Electric Motor Change

Close-Coupled Regenerative Turbine Pumps—Coro-Flo®

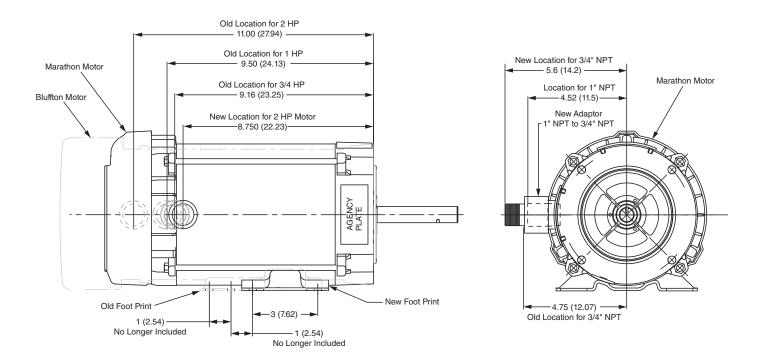
Effective immediately, the 1 HP Bluffton motor currently used on Coro-Flo regenerative turbine pump models C10, C12, C13, CF10, CF12, and CF13 is being replaced with a 2 HP Marathon motor. The new motor configurations are 2 HP (standard) and 3 HP (optional). The dimensions for the new 2 HP Marathon motor are slightly different than the previously used 1 and 2 HP Bluffton motors so the conduit location and foot print will change. The illustration below is a dimensional comparison between the previously used Bluffton motors (3/4, 1, and 2 HP) and the new 2 HP Marathon motor. If you are replacing one of the models mentioned above or installing a new one, please review the new dimensions carefully before mounting the 2 HP Marathon motor or installing the electrical piping.

Please note: The S-30 and SM-30 switch assemblies for the 2 HP motor do not include thermal override protection.
